Re: PD Plan & Preliminary Plat, Centerstate East Subdivsion (Minor Amendment)

By means of this letter I am approving your request for a minor amendment to the PD development plan known as the, "PD Plan & Preliminary Plat, Centerstate East Subdivision", bearing your seal dated October 17, 2025.

PD PLAN & PRELIMINARY PLAT - PLAT

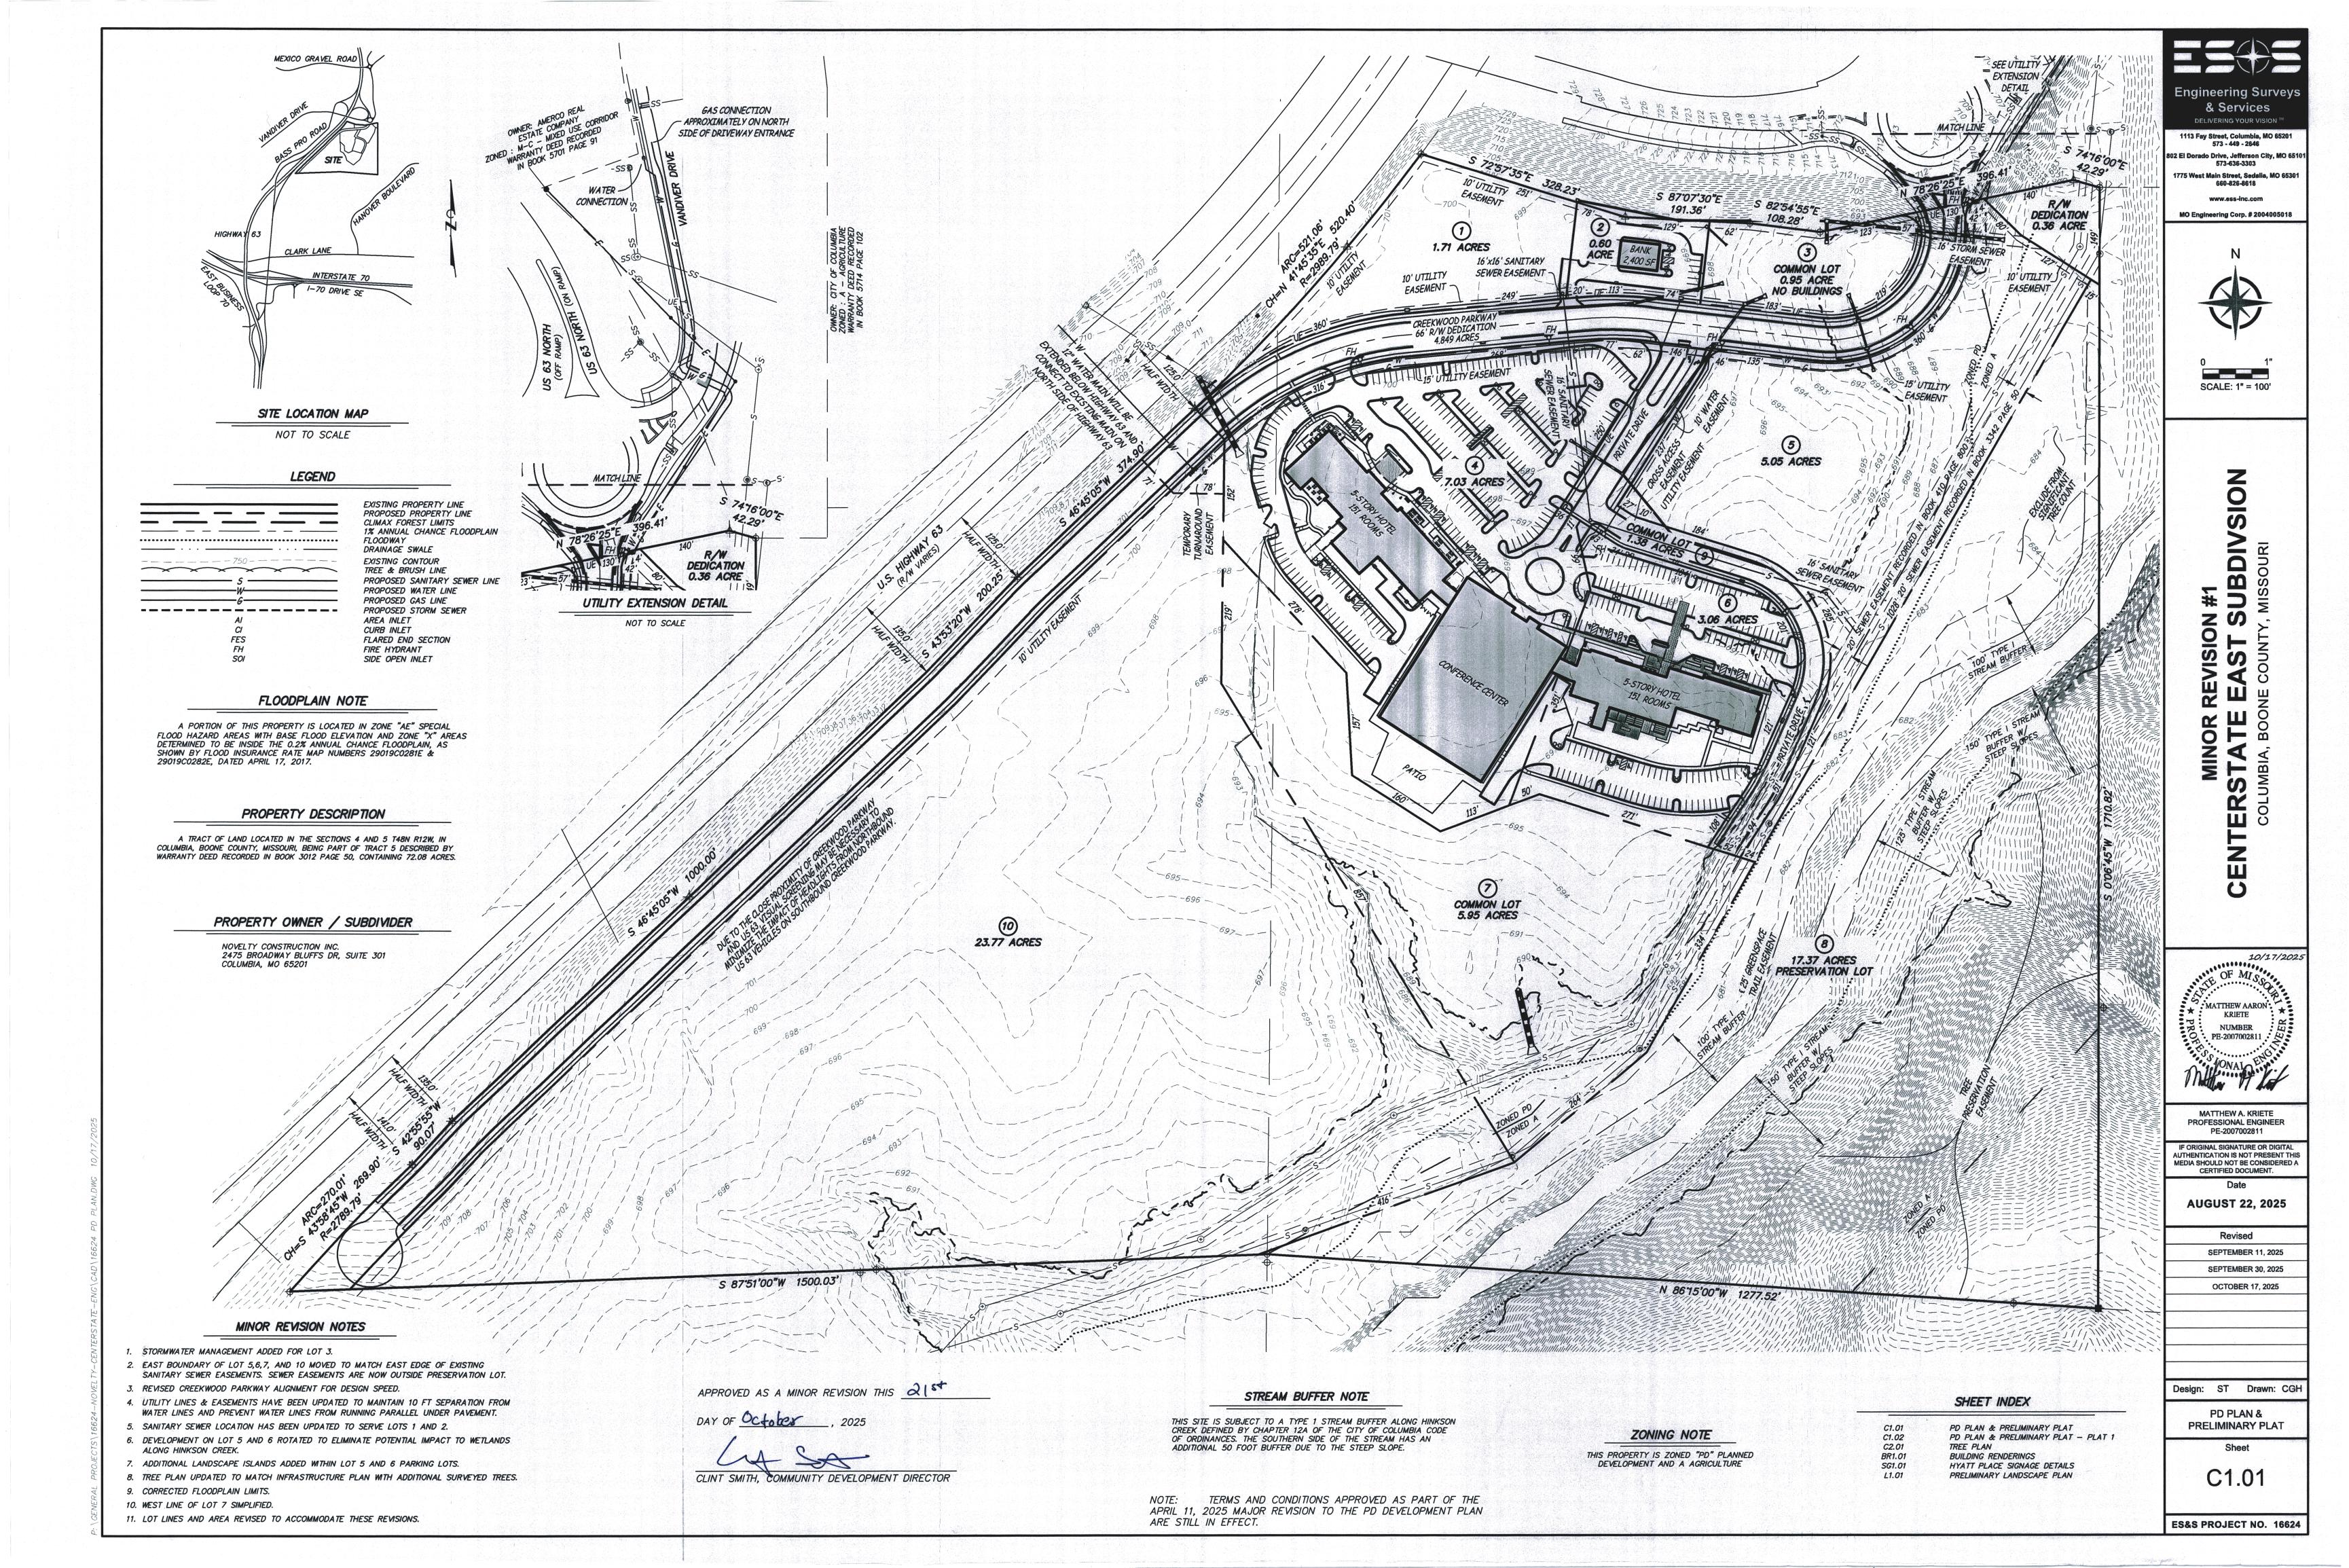
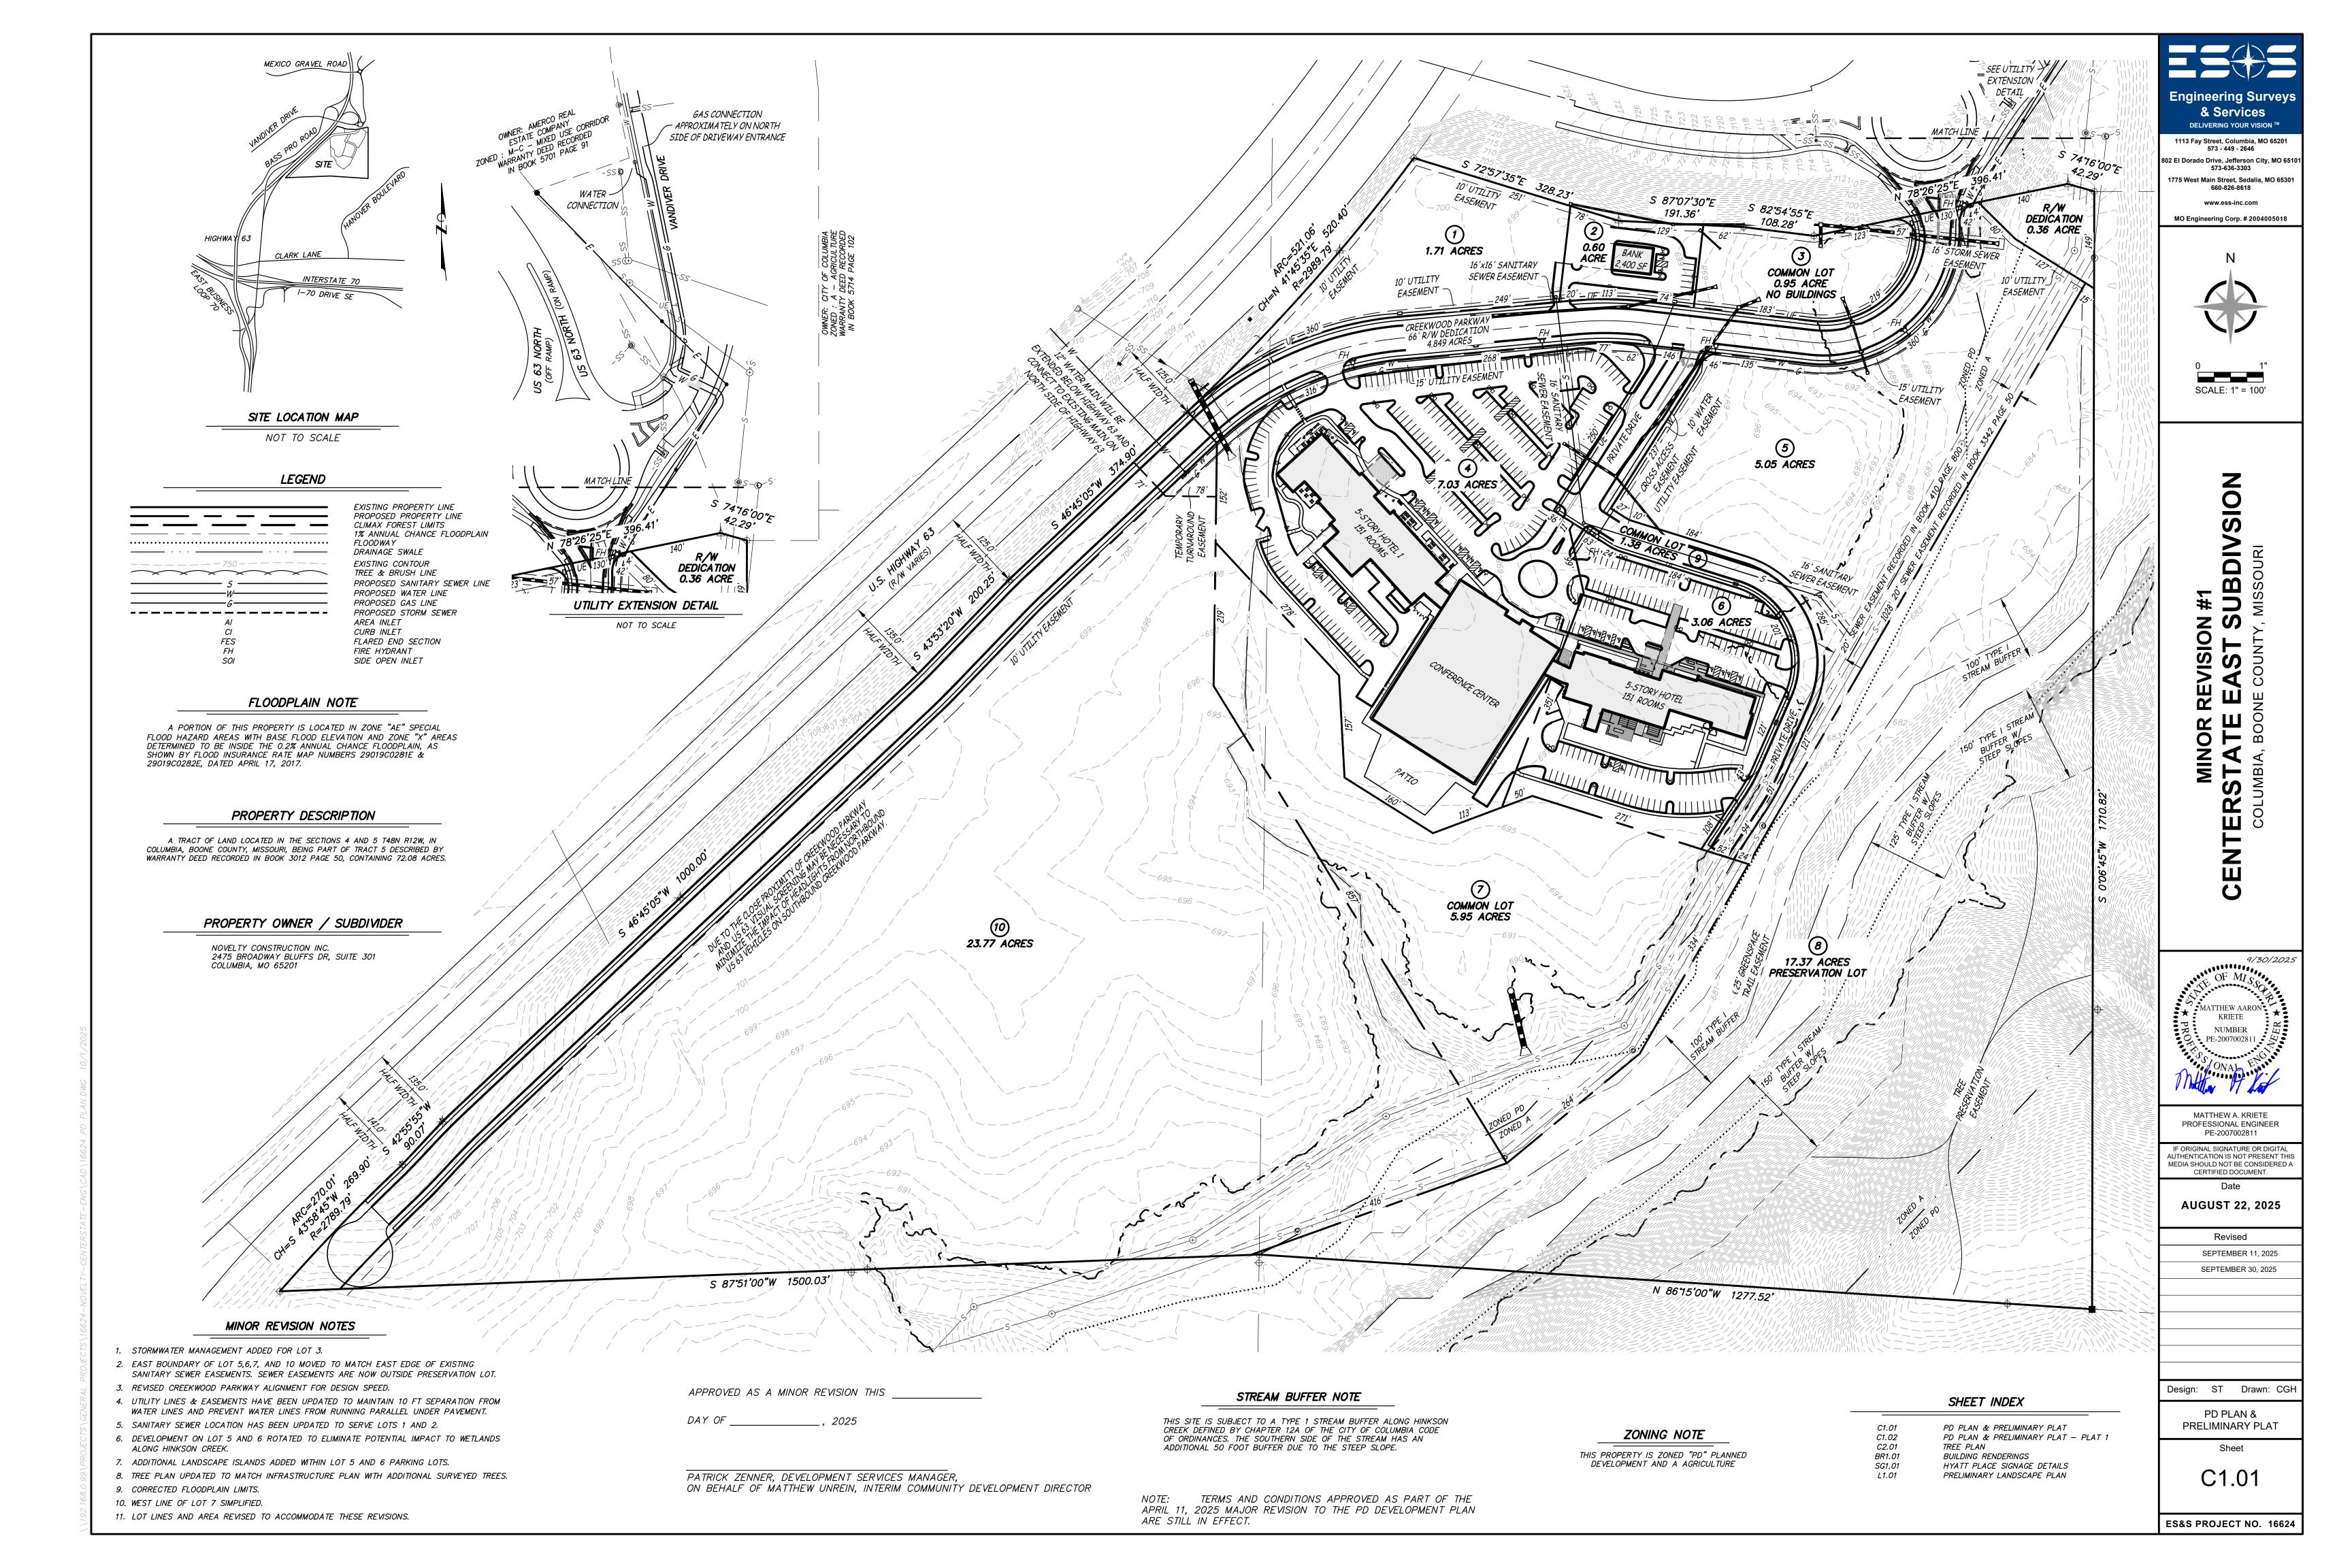
- 1. Common stormwater management added to Lot 3.
- 2. East boundary of Lot 5, 6, 7, and 10 moved to match east edge of existing sanitary sewer easements. Sewer easements are now outside preservation lot.
- 3. Revised Creekwood Parkway alignment for design speed.
- 4. Utility lines & easements have been updated to maintain 10-ft separation from water lines and prevent water lines from running parallel under pavement.
- 5. Sanitary sewer location has been updated to serve Lots 1 and 2.
- 6. Improvements on Lot 5 & 6 rotated to eliminate potential impact to wetlands along Hinkson Creek.
- 7. Additional landscape islands were added within Lot 5 and 6 parking lots.
- 8. Tree plan updated to match Infrastructure plan with additional surveyed trees.
- 9. Corrected floodplain limits.
- 10. West line of Lot 7 simplified.
- 11. Lot lines and areas revised to accommodate these revisions.
